RETREAT AT TIMBERRIDGE FILING NO. 4

UTILITY CONSTRUCTION DRAWINGS

FEBRUARY 2024

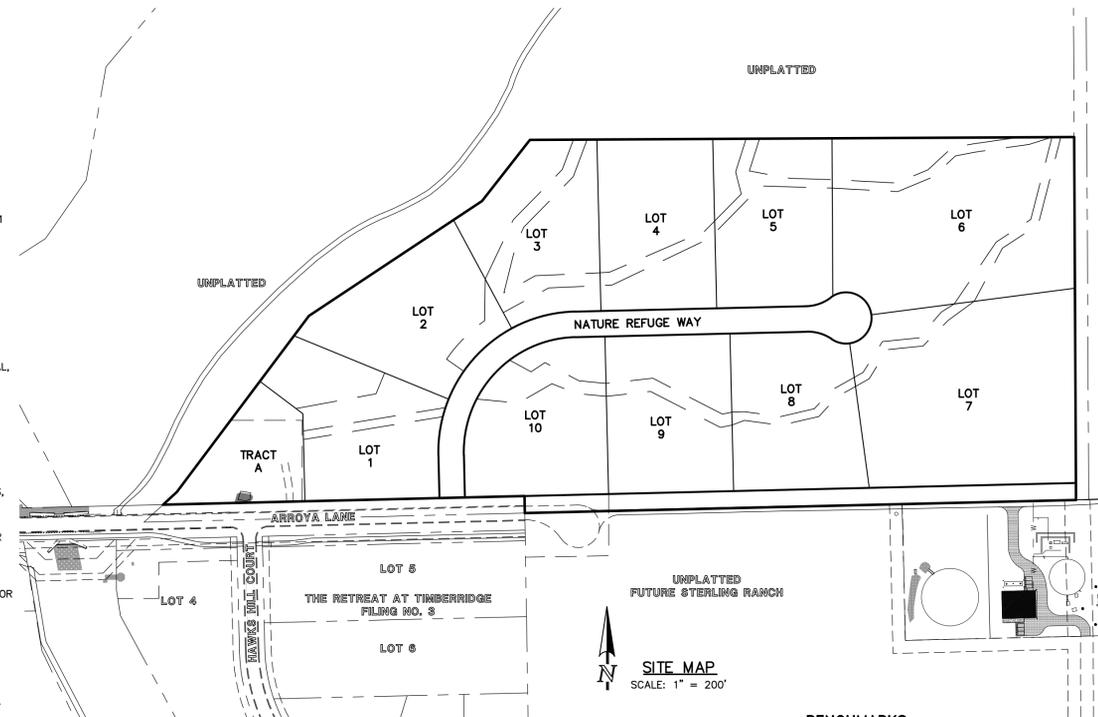
change all PCD to DPW

RETREAT AT TIMBERIDGE FILING NO. 4 CONSTRUCTION PLANS PUBLIC 8" PVC WATER PLAN			
DESIGNED BY	PRA	SCALE	DATE 2-29-24
DRAWN BY	PRA	(H) 1" = 50'	SHEET 2 OF 3
CHECKED BY	(V) 1" = N/A	JOB NO.	1185.31

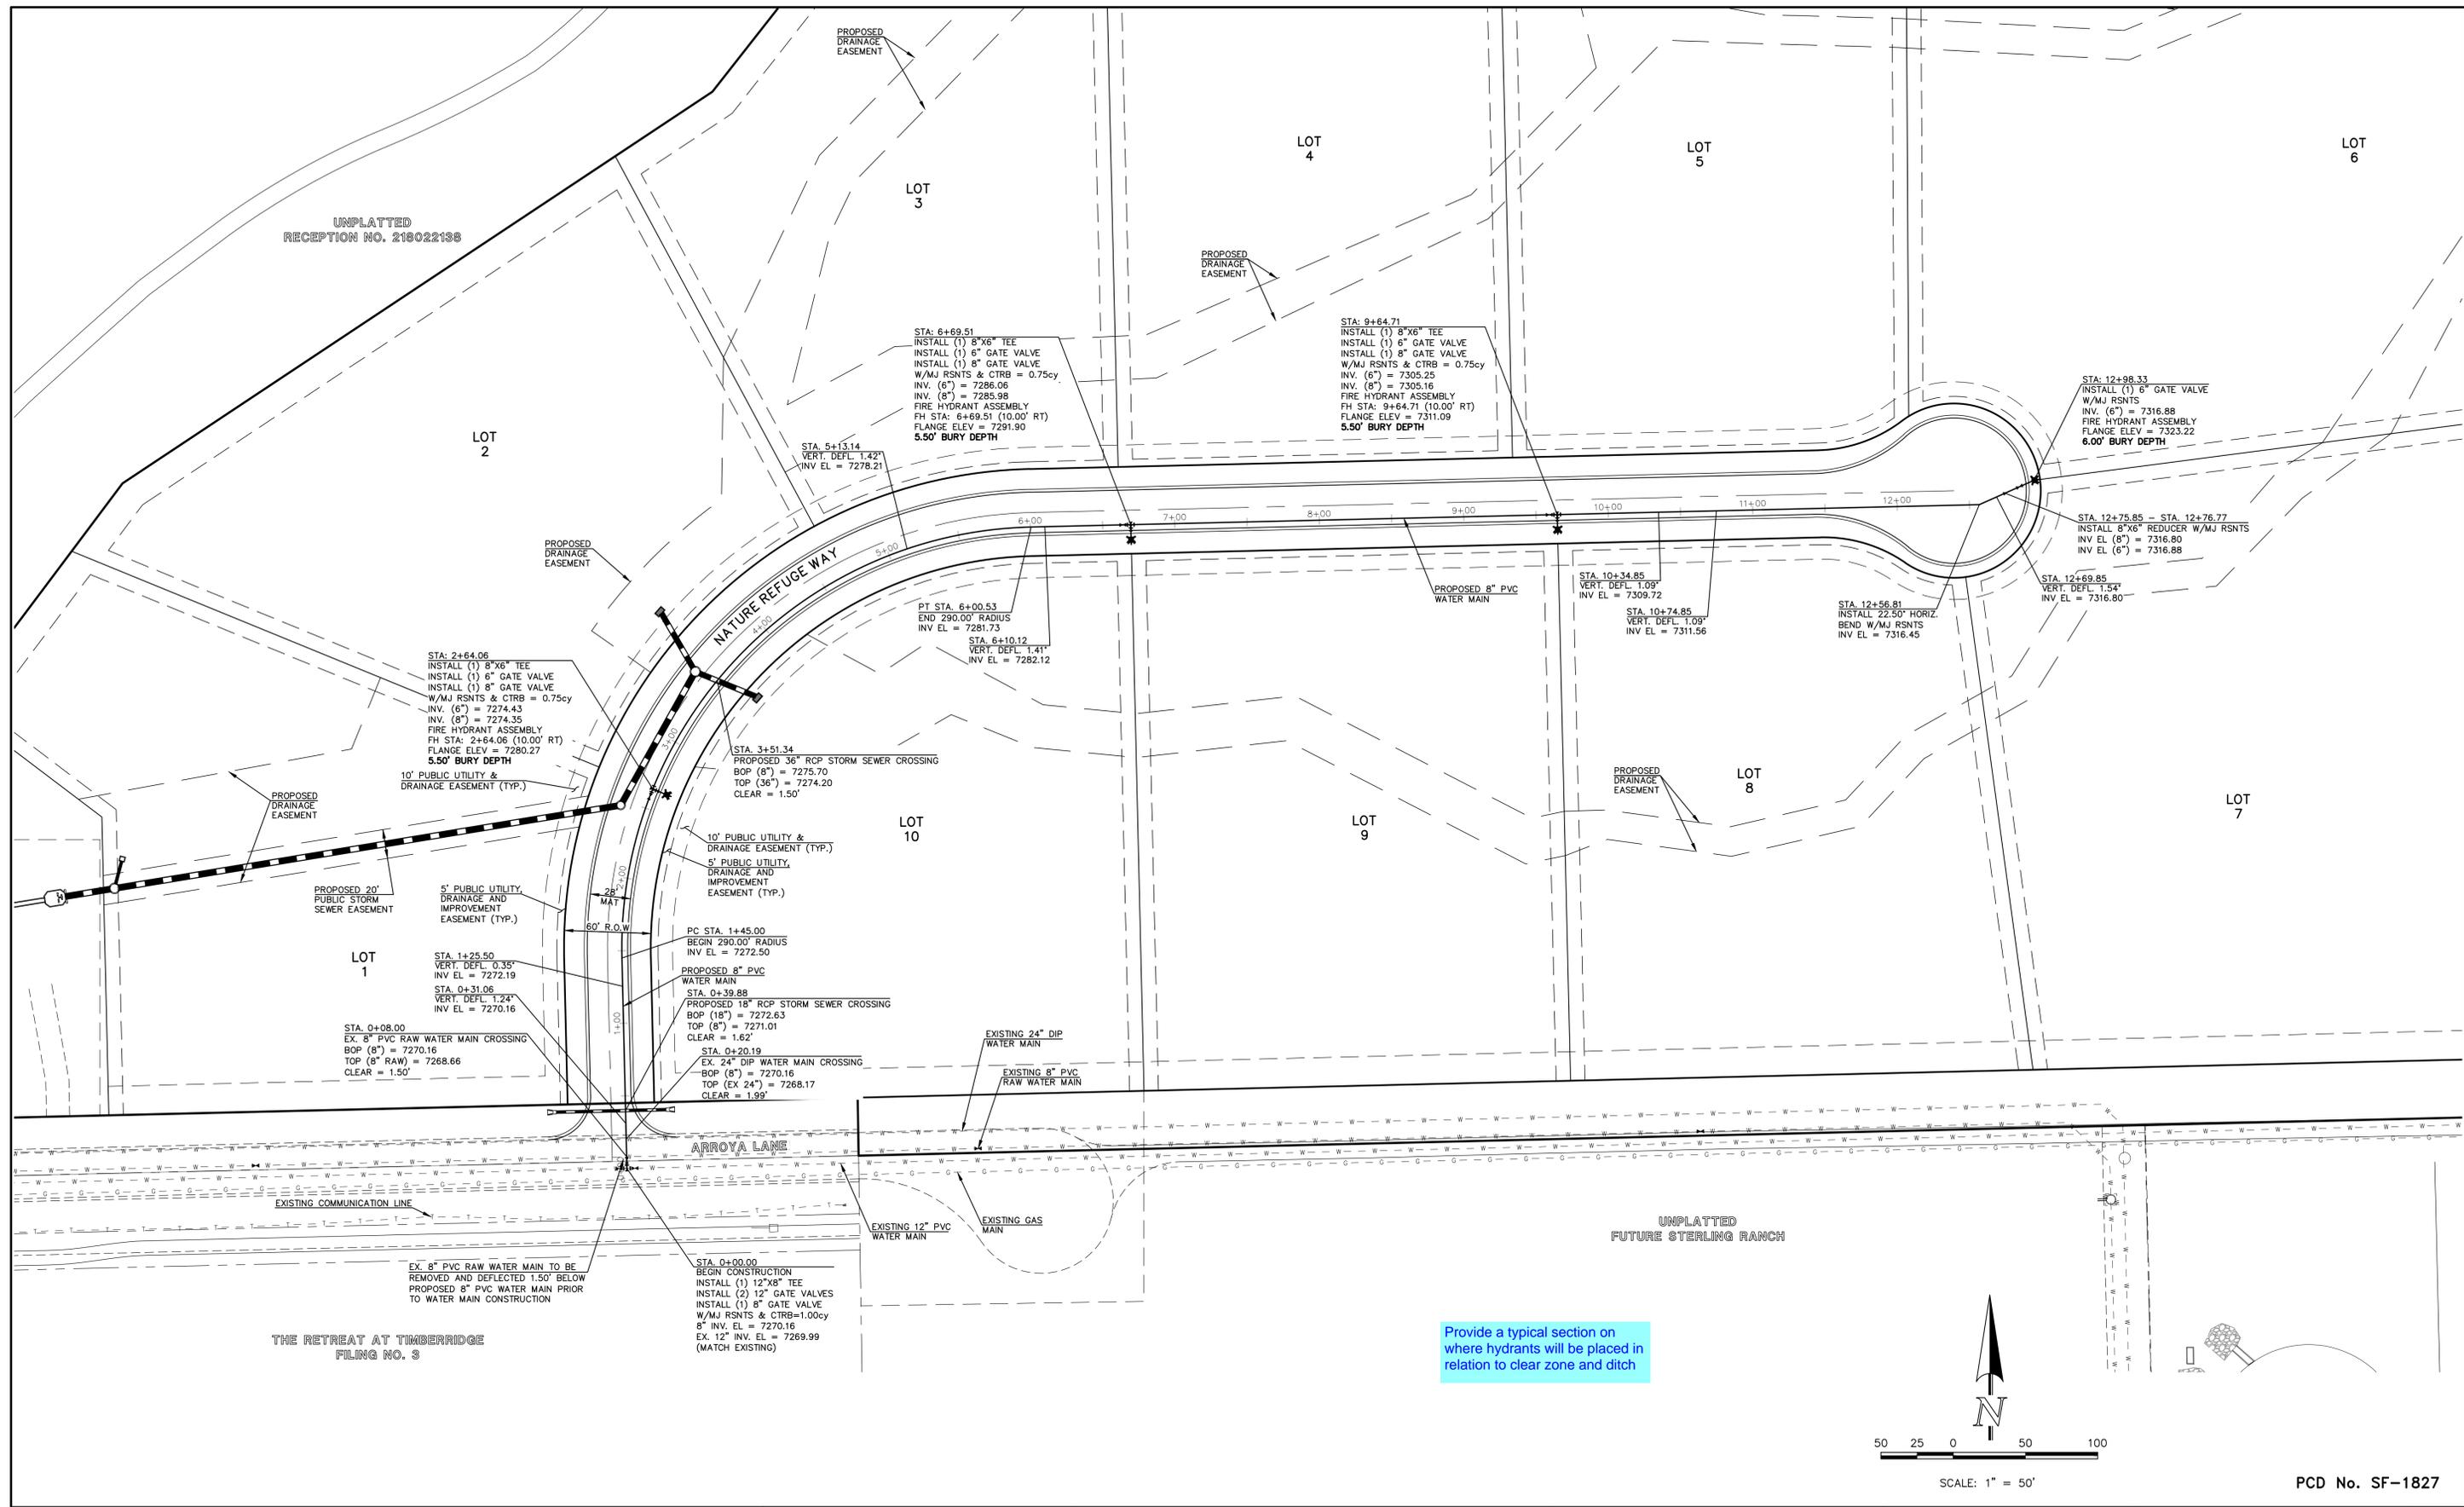
Provide a typical section on where hydrants will be placed in relation to clear zone and ditch

RETREAT AT TIMBERIDGE FILING NO. 4 CONSTRUCTION PLANS UTILITY SERVICE PLAN			
DESIGNED BY	PRA	SCALE	DATE 2-29-24
DRAWN BY	PRA	(H) 1" = 60'	SHEET 3 OF 3
CHECKED BY		(V) 1" = N/A	JOB NO. 1185.31

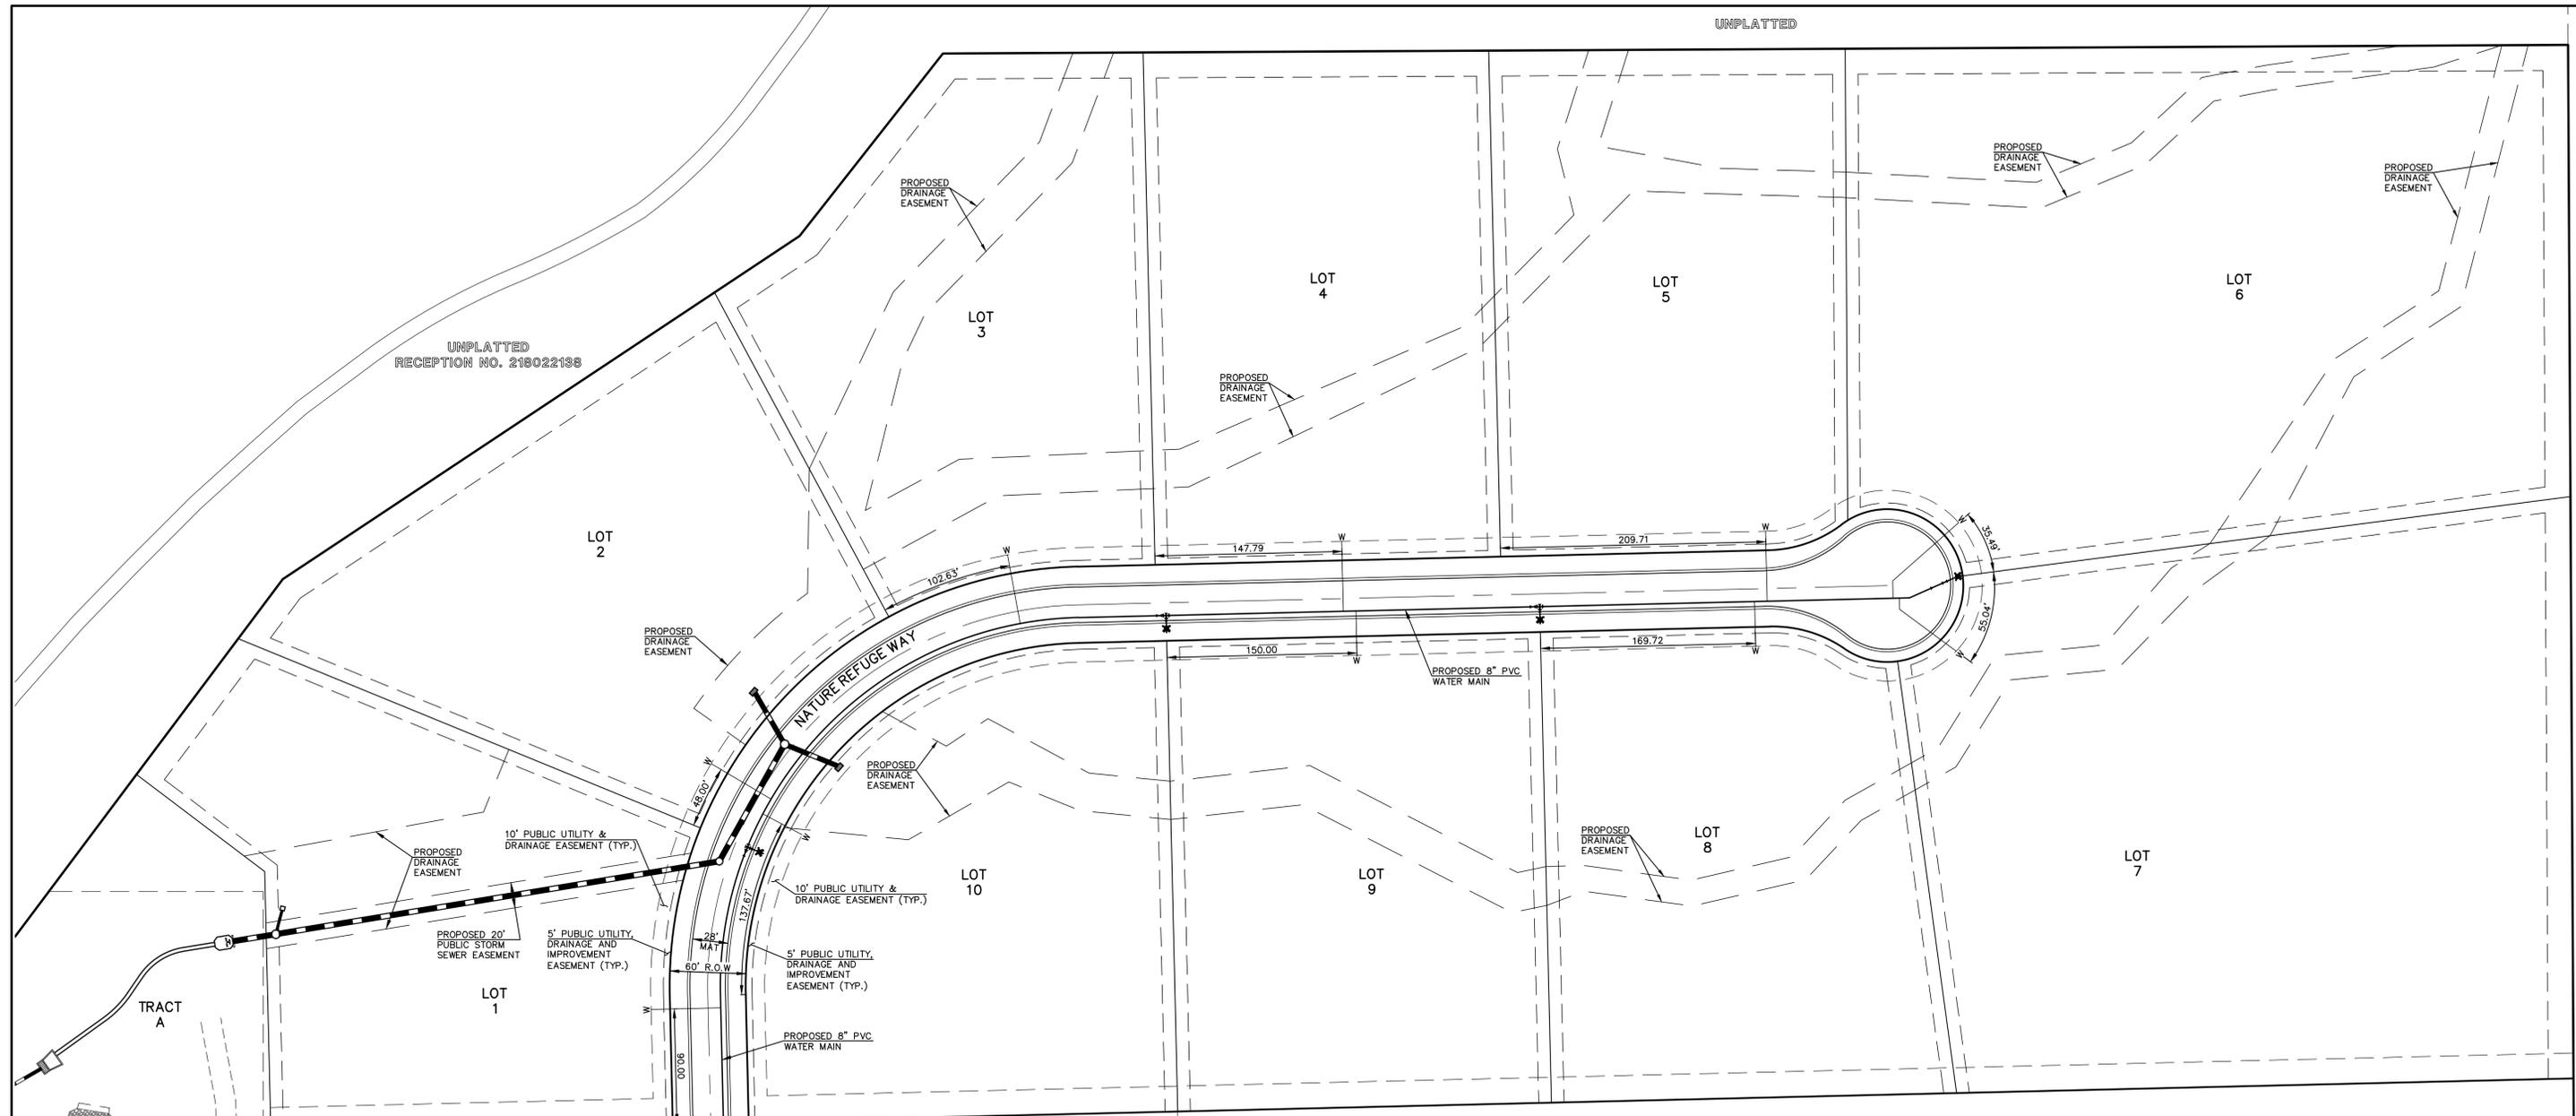
- NOTES:
- 1.) DIMENSIONS SHOWN ARE TYPICAL UNLESS OTHERWISE NOTED ON PLANS.
 - 2.) SEE DISTRICT SPECS. FOR TAPPING SADDLE DETAIL.
 - 3.) FINAL LOCATION OF ALL SEWER, WATER AND GAS SERVICES TO BE APPROVED IN THE FIELD BY THE CONSTRUCTION MANAGER PRIOR TO INSTALLATION.
 - 4.) WATER SERVICES INSTALLED TO BE MARKED WITH A 6"x2"x4" POST EXTENDING 4' BELOW FINISH GRADE.
 - 5.) IT SHALL BE THE CONTRACTOR'S RESPONSIBILITY TO NOTIFY THE DISTRICT AND COORDINATE ANY INTERRUPTION TO EXISTING WATER SERVICE.
 - 6.) RE-USE OF ANY MATERIAL IS LEFT TO THE DISCRETION OF THE DISTRICT.
 - 7.) ALL WATER MAIN FITTINGS SHALL BE STAKED PRIOR TO CONSTRUCTION.
 - 8.) ALL FIRE HYDRANTS TO BE 5.50' OR 6.00' BURY DEPTH UNLESS OTHERWISE NOTED.
 - 9.) MODIFY WATER SEWER SERVICE TAP LOCATIONS TO AVOID DRIVEWAYS
